40600-HS-MEM-55039 Revision 0 Permit Addendum: Maintenance Dredging Technical Memorandum

Subject: NWS-2017-715 (HPA App. #12746) Permit Application Addendum:
Maintenance Dredging
BHP Proposed Grays Harbor Potash Export Facility (A17.0202.00)

**Proposed Grays Harbor Potash Export Facility-
Permit Addendum Maintenance Dredging**

Sheet 2 - Dredge Area and Bathymetry

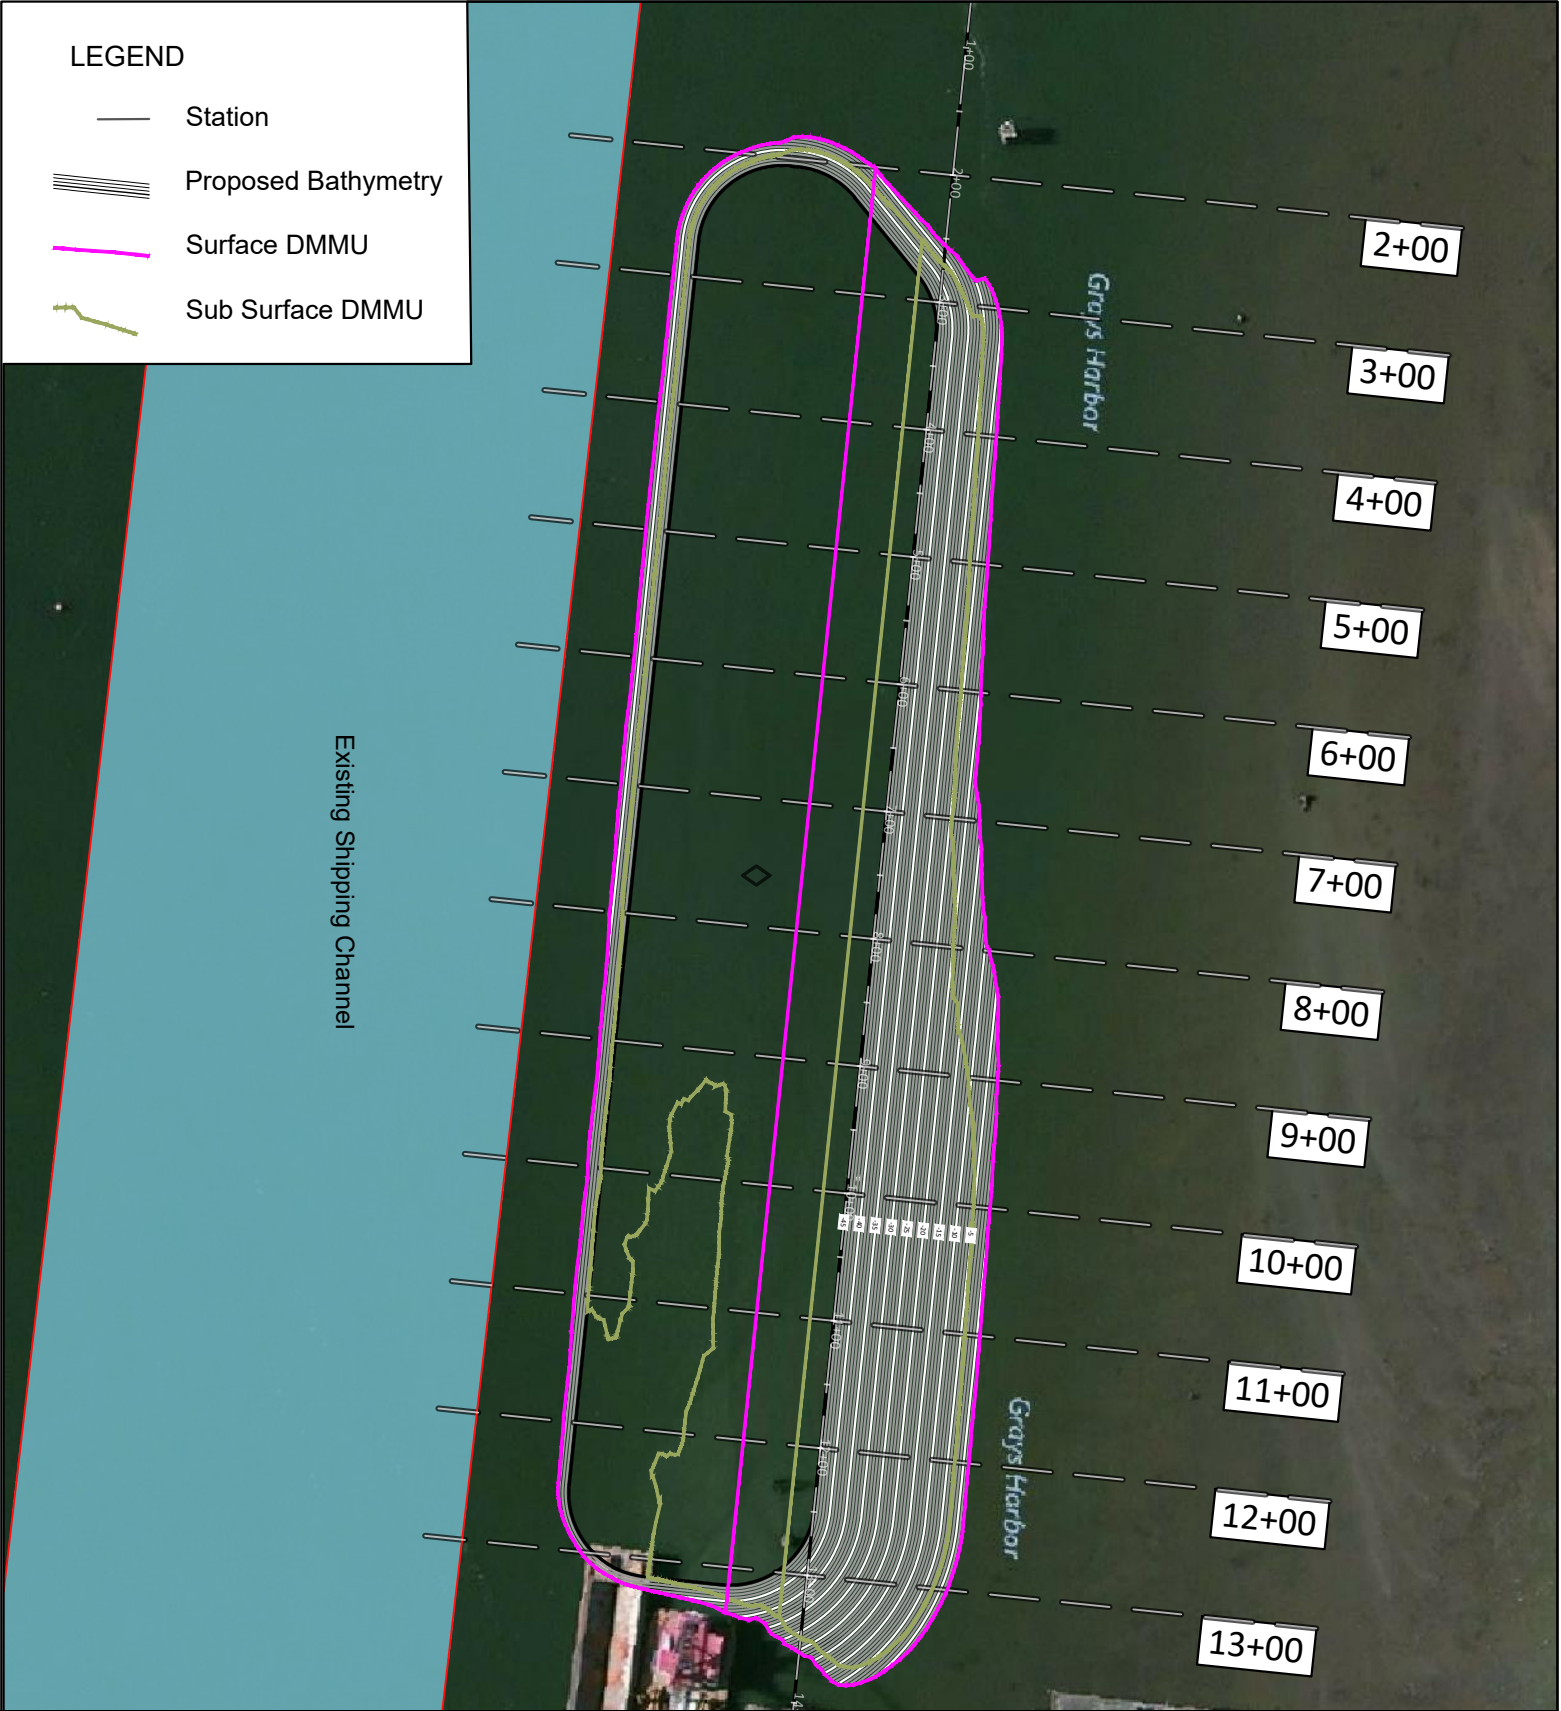
The dredge prism design was revised after current bathymetric data was obtained (Berglund, Schmidt and Associates, December 2017) and previously obtained geotechnical information and Terminal 3 berth design details were evaluated. The revised dredge prism (Sheet 2) is smaller in volume and area than the dredge prism design that was included with the original permit application submittal for this project. The dredging volume changed from 184,000 cubic yards to 110,000 cubic yards after the dredge prism redesign was completed. The design depth for the berth remains the same at -43 feet mean lower low water (MLLW) plus 2 feet of allowable

overdredge. The updated design minimizes dredging of the intertidal zone; almost all dredging is located below 0 feet MLLW.
